SMS		COD.SMS ZZOB063800		TOL. GERAL NAO SE APLICA	
TITULO ESQUEMA ELETRICO		DES.		VISTOS EDISON	DATA 05 / 01 / 04
MAT. NAO SE APLICA		CONF.			
TRAT. NAO SE APLICA		APROV.			
APLIC. REVOLUTION III L Bi - uRL		ESC. S / E		DES.No T03337- 02

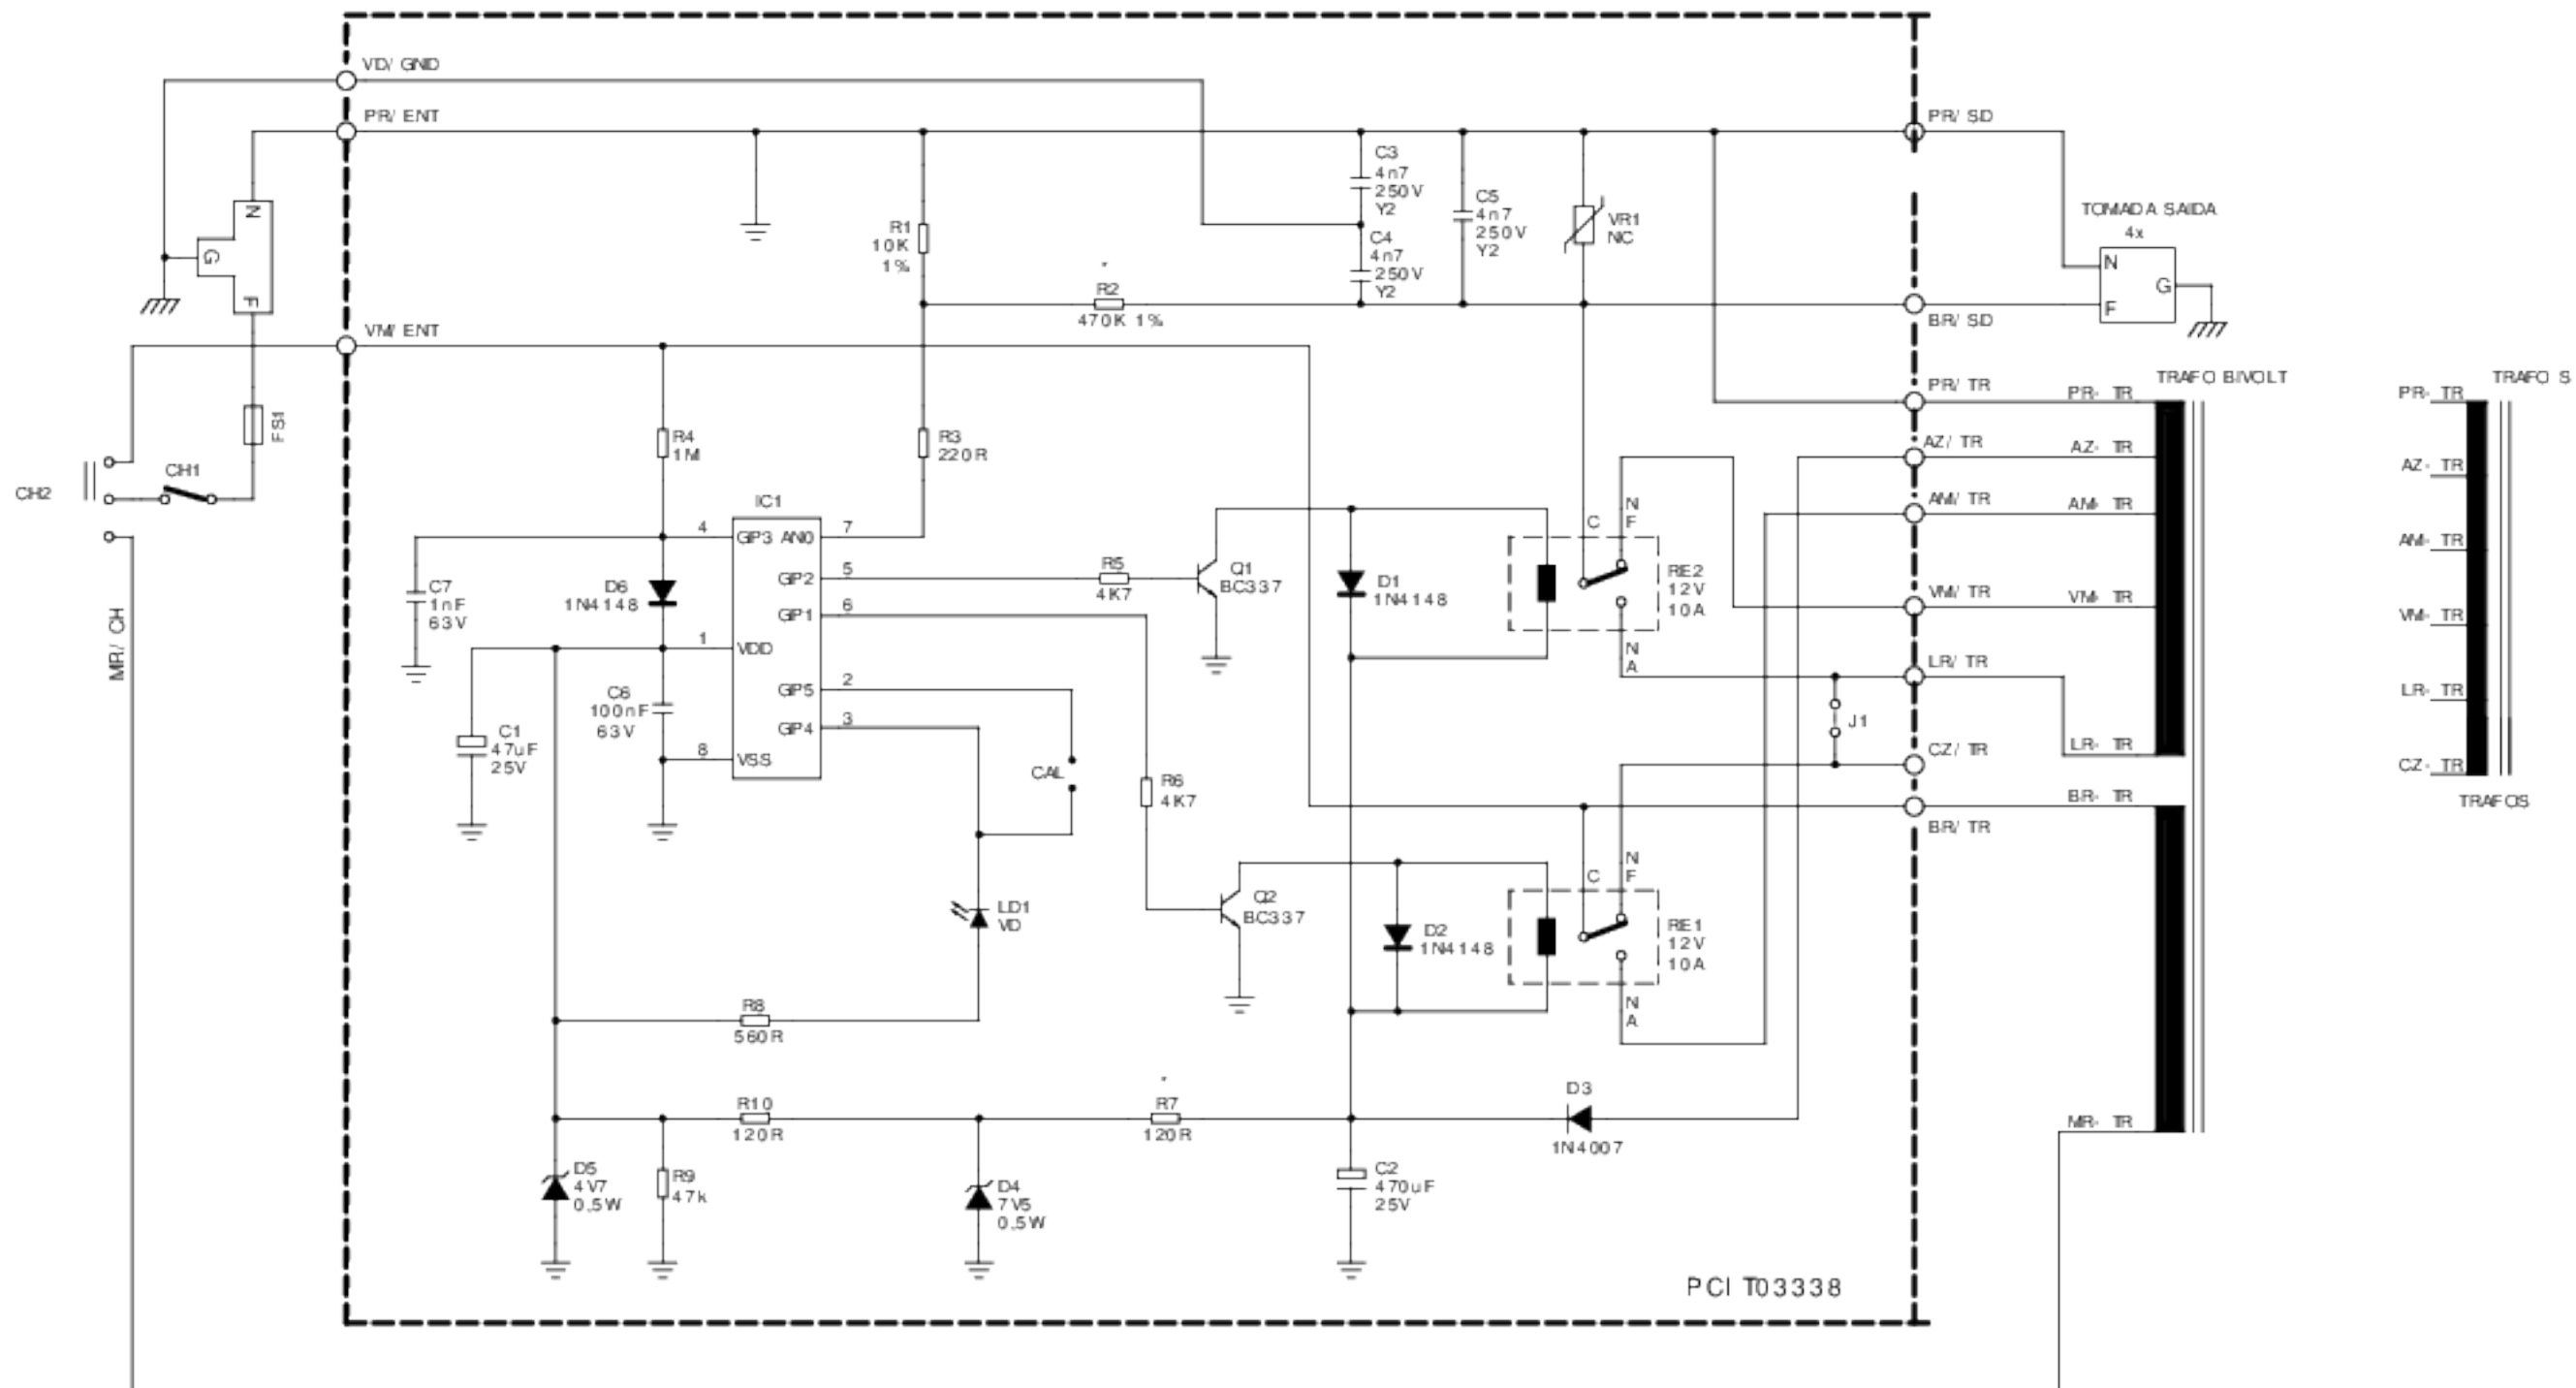
REV.	DESCRICAO	VISTOS	DATA
01	ACRESCENTADO R9 - 47k	OSVALDO	10 / 05 / 05
02	ALTERADO C3, C4, C5 DE NC PARA 4,7nF 250Vac Y2	WILLIAN	25 / 10 / 05
